Work Order ID 101170

Item Name: Crosstube Turning Detail

DRAWING NO. D212-664-241		TITLE CROSSTUBE ASSY (205/212 HI AFT)		REV. D DART AEROSPACE LTD ENGINEERING ORDER		D.E.O. NO. D212-664-241-D-1		SHEET NO. SHEET 1 OF 2		SCALE NTS	
DRAWN		CHECKED		MFG. APPR.		APPROVED		DE APPR.			
DATE 11.04.07		DATE 11.04.11		DATE 11.04.12		DATE 11/04/12		DATE 11.04.12

ADD AN INSPECTION WINDOW TO UNDERSIDE OF CROSSTUBE.

**D212-664-241/-241B
ASSEMBLY DETAIL**

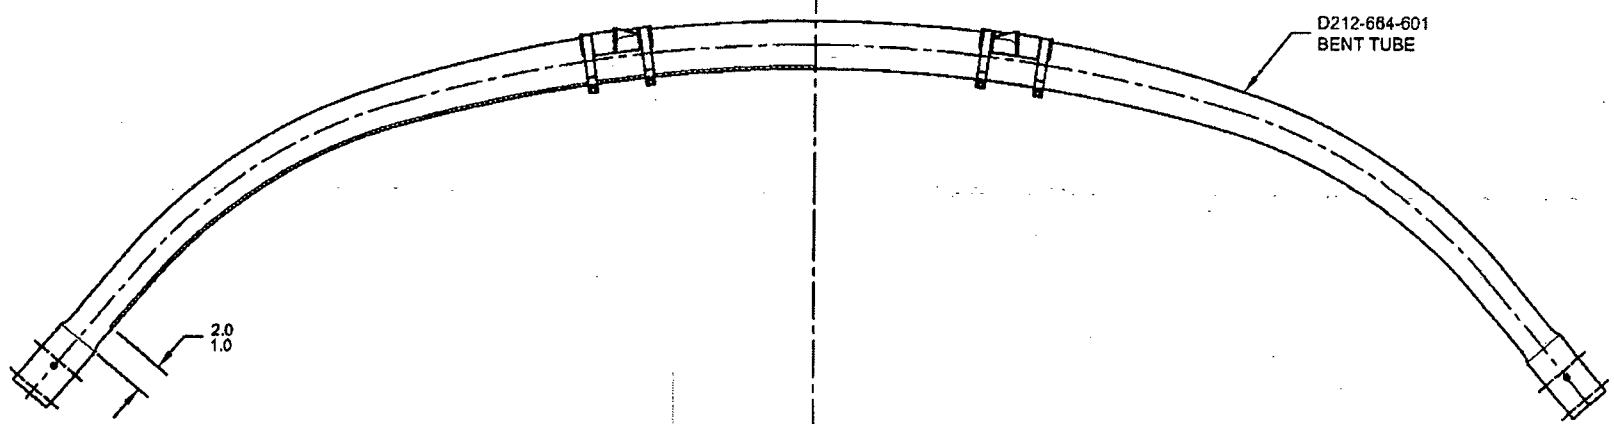
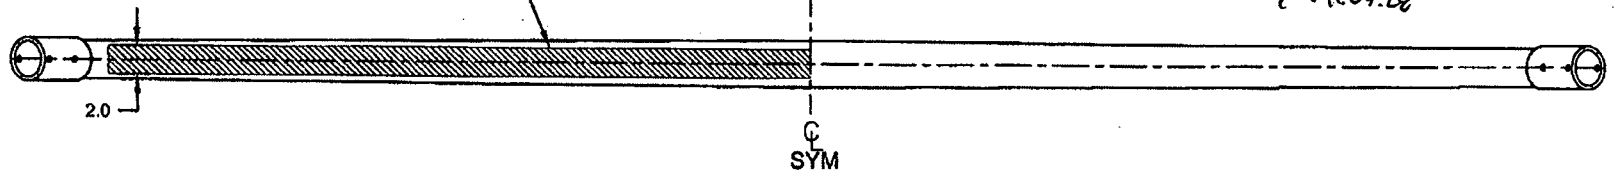
NOTES 2 OF SHEET 1 IS AMENDED AS FOLLOWS:

- 2) FINISH: CHEMICAL CONVERSION COAT PER DART QSI 005 4.1
PRIME INSIDE AND OUTSIDE PER DART QSI 005 4.2
MASK UNDERSIDE OF CROSSTUBE AS SHOWN (HATCHED AREA) AND
PAINT OUTSIDE PER DART QSI 005 4.2
REMOVE MASKING AND APPLY CLEAR COAT

- 2) FINISH: CHEMICAL CONVERSION COAT PER DART QSI 005 4.1
PRIME INSIDE AND OUTSIDE PER DART QSI 005 4.2
PAINT OUTSIDE PER DART QSI 005 4.2

MASK AREA PRIOR TO PAINTING,
REMOVE MASKING AFTER PAINT
AND APPLY CLEAR COAT
